Final Environmental Impact Statement for the Ball Hill Wind Project Chautauqua County, New York Volume 1

November 2016

ecology and environment, inc.
Global Environmental Specialists

Figure 1
Project Facilities
 Ball Hill Wind Project
 Chautauqua County, New York
 Ball Hill Wind Energy, LLC

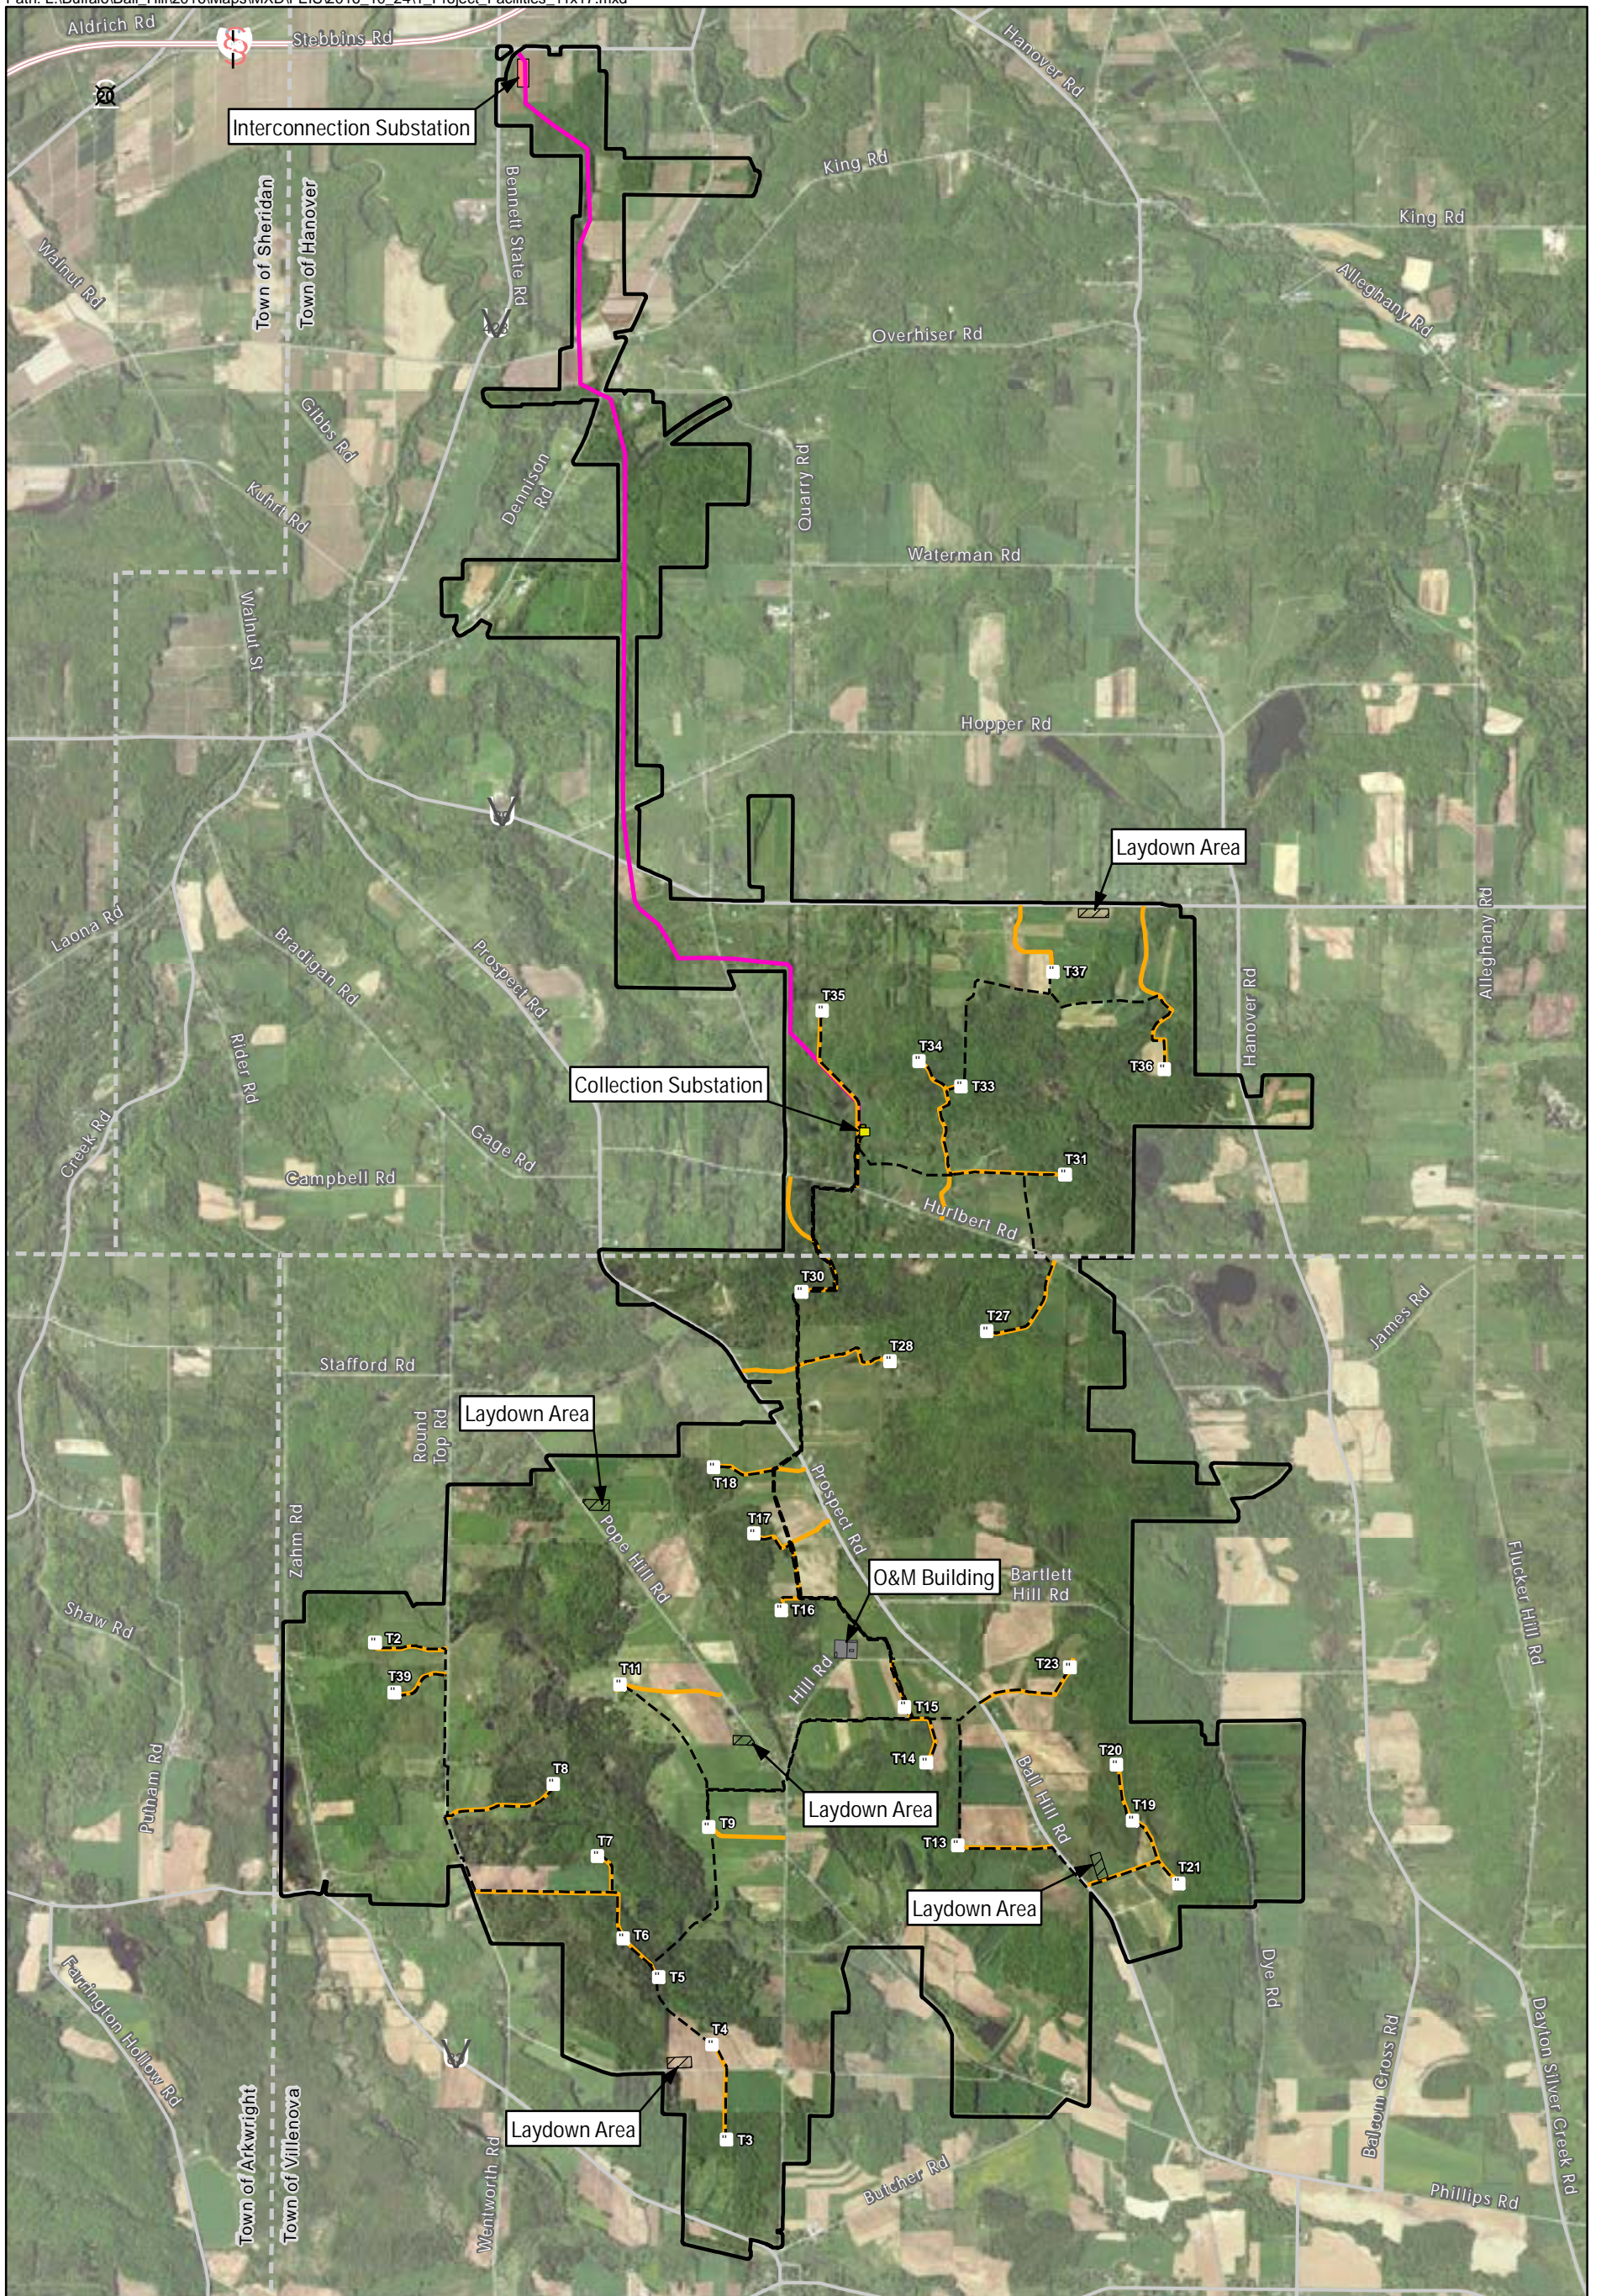
Unique Comment ID	Commenter Name or Agency	Comment	Comment Response
DEIS-0004-18	Diana Robinson	*Setback for permanent residences should be reconfigured to .96 mile (5068 ft.) Note; Even for only half the distance or a .50 mile (2640 ft) the following turbines near our home would have to be disallowed: T-2 (2500 ft), T-3 (2000 ft), T-4 (1200 ft) T-5 (2000 ft), T-7 (1500 ft).	There are zero residences within 1,200 feet of a turbine in the FEIS Layout. Figure 1 in Section 1 of the FEIS identifies the location of the Project facilities.
DEIS-0004-19	Diana Robinson	*T-4 should not be allowable. There is a residence within 500 feet not shown on master map Figure 2.23 - 2 Setback Map. This is too close a proximity whether a seasonal or permanent residence. And, this property is less than a fifty acre parcel.	There are zero residences within 1,200 feet of a turbine in the FEIS layout. Figure 1 in Section 1 of the FEIS identifies the location of the Project facilities.

DEIS-0004-20	Diana Robinson	*Set back -distance for seasonal homes should be established due to health concerns, blade failure, ice on blades etc.	There are zero residences within 1,200 feet of a turbine in the FEIS layout. Figure 1 in Section 1 of the FEIS identifies the location of the Project facilities.
DEIS-0004-21	Diana Robinson	*Our frontage is incorporated within T-4's 1000 ft. setback circle. This would be a detriment to our building a home or selling lots along our road frontage.	There are zero residences within 1,200 feet of a turbine in the FEIS layout. Figure 1 in Section 1 of the FEIS identifies the location of the Project facilities.
DEIS-0004-24	Diana Robinson	* Research multiple options, such as the new wind silos, geothermal, etc. Obtain some competing studies for our township and then choose direction.	Section 1 of this FEIS outlines the proposed Project layout for this Project.

Figure 2
Project Comparison
 FEIS Layout (November 2016) SDEIS layout (January 2016)
 Chautauque County, New York
 Ball Hill Wind Energy, LLC

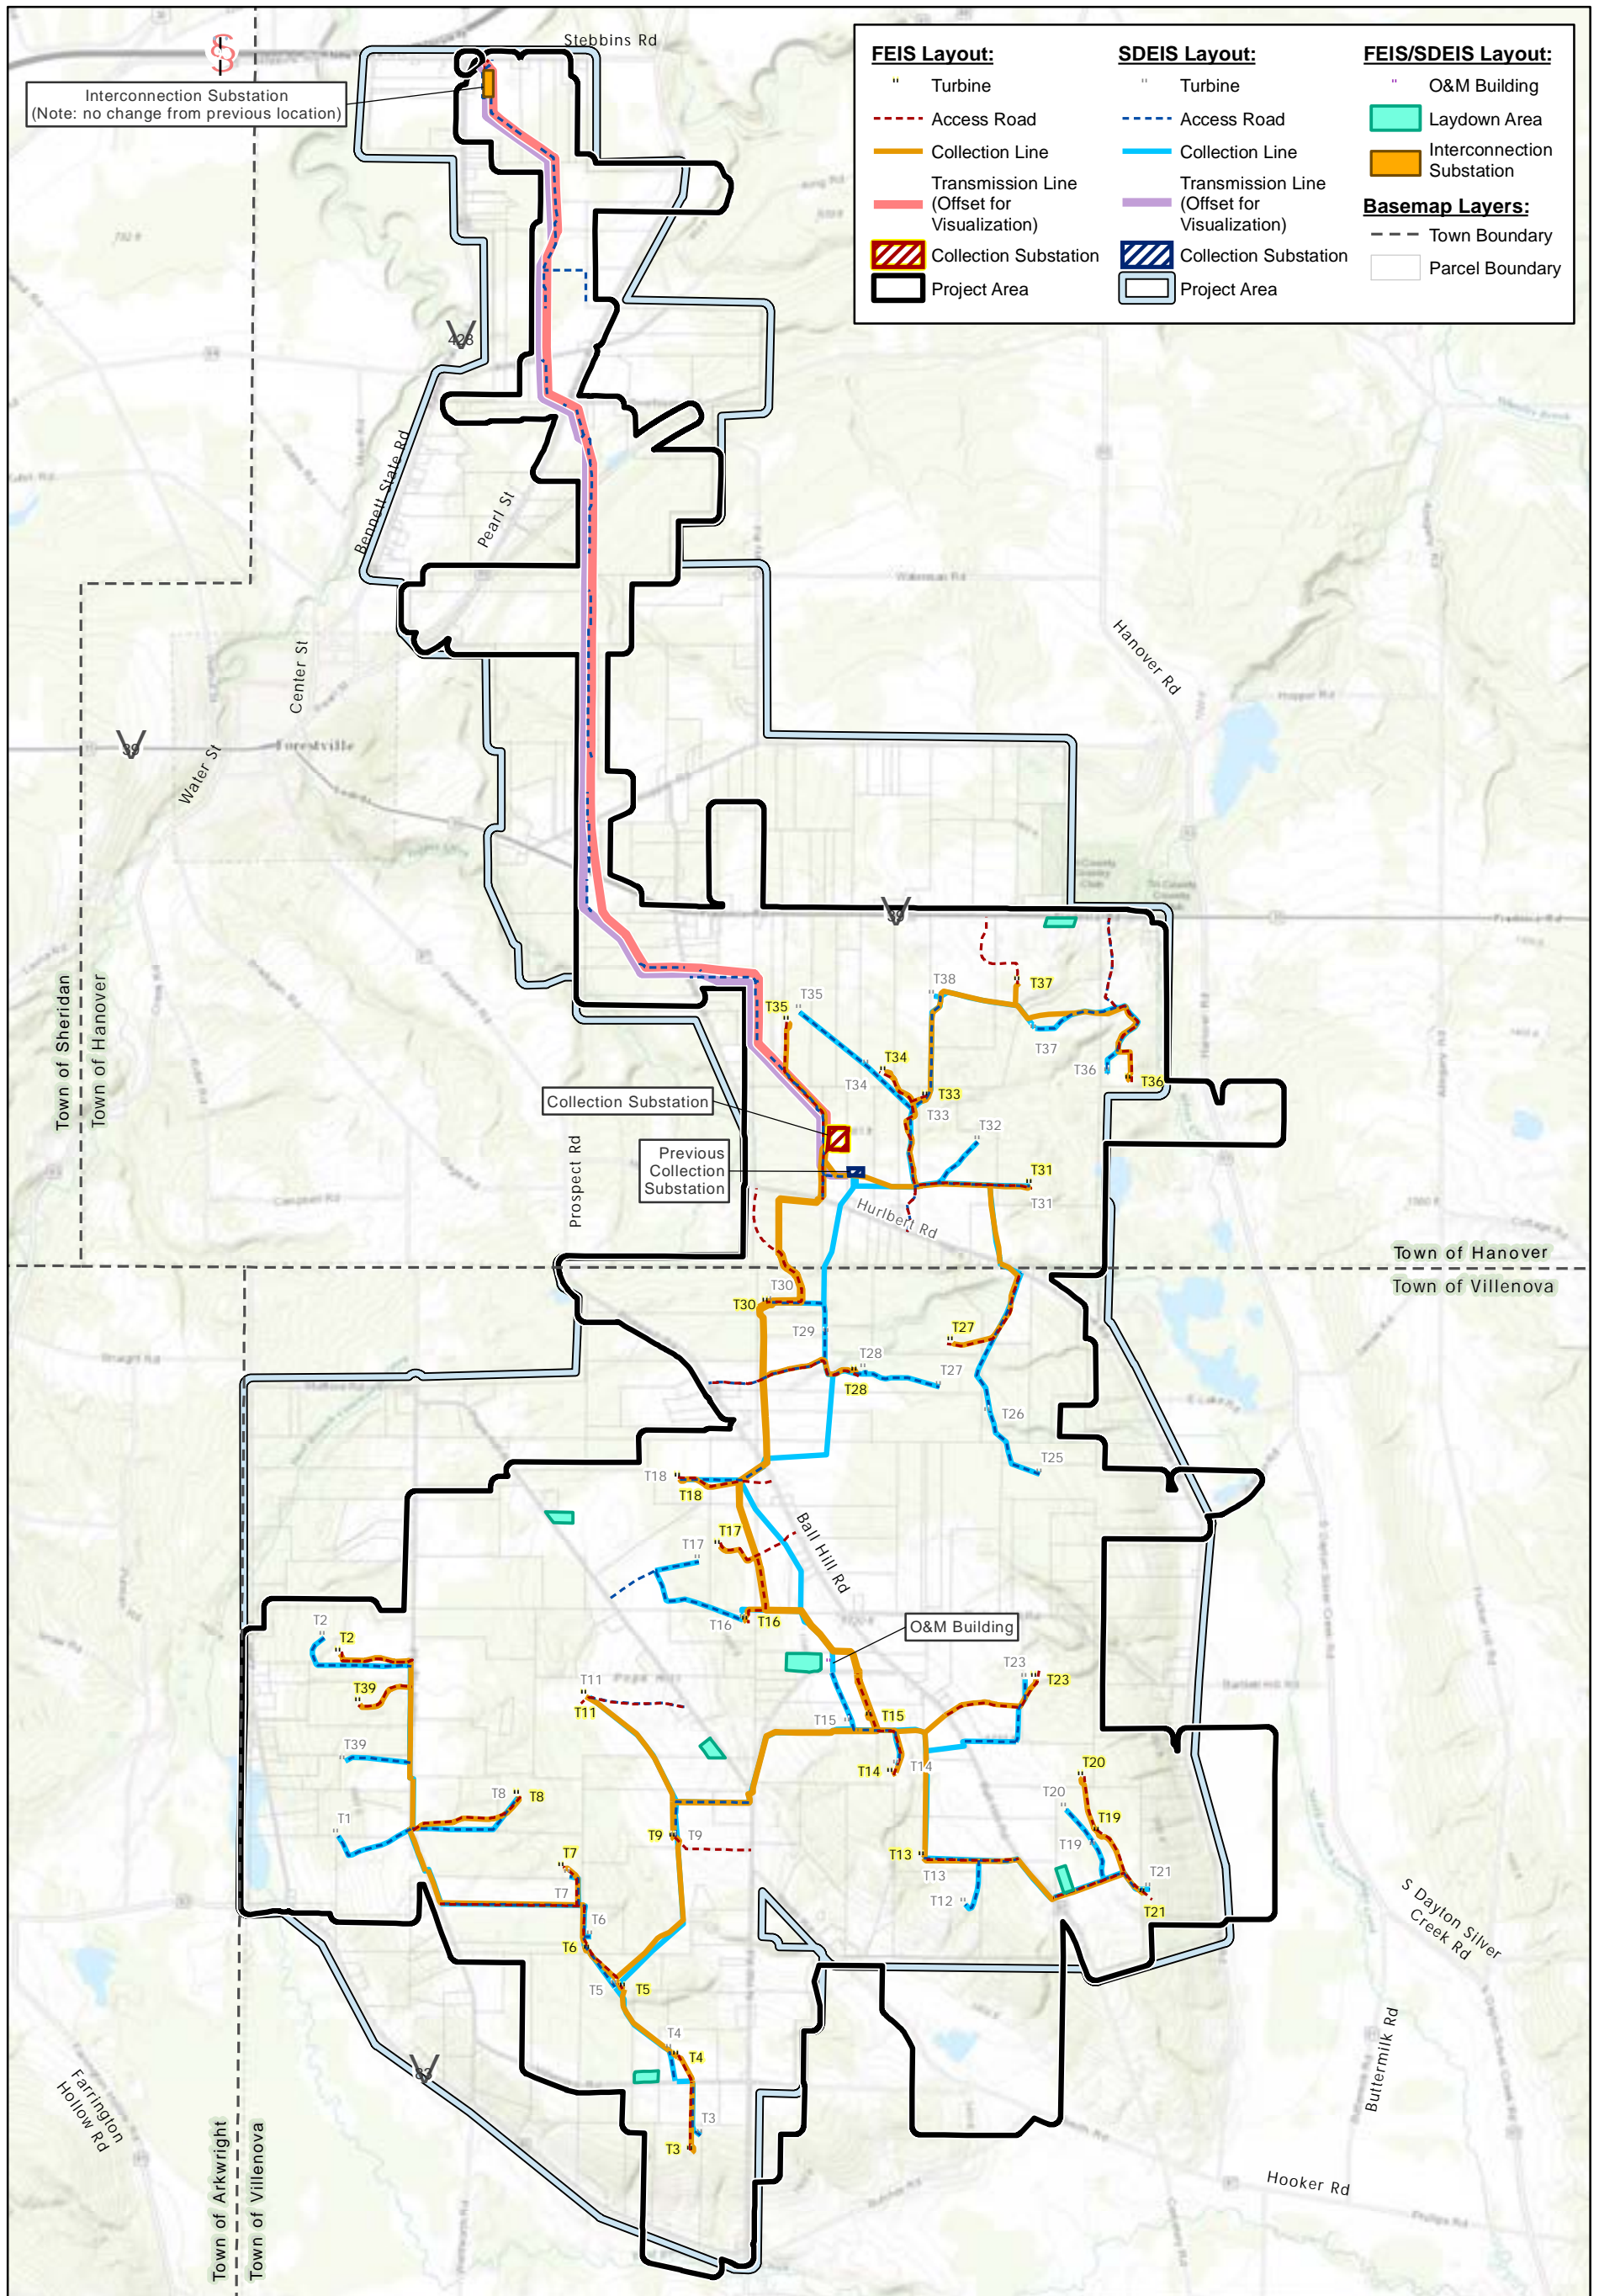
Figure 1 shows all proposed Project facilities. Figure 2 illustrates both the January 2016 SDEIS and FEIS layouts to highlight changes in the Project layout.
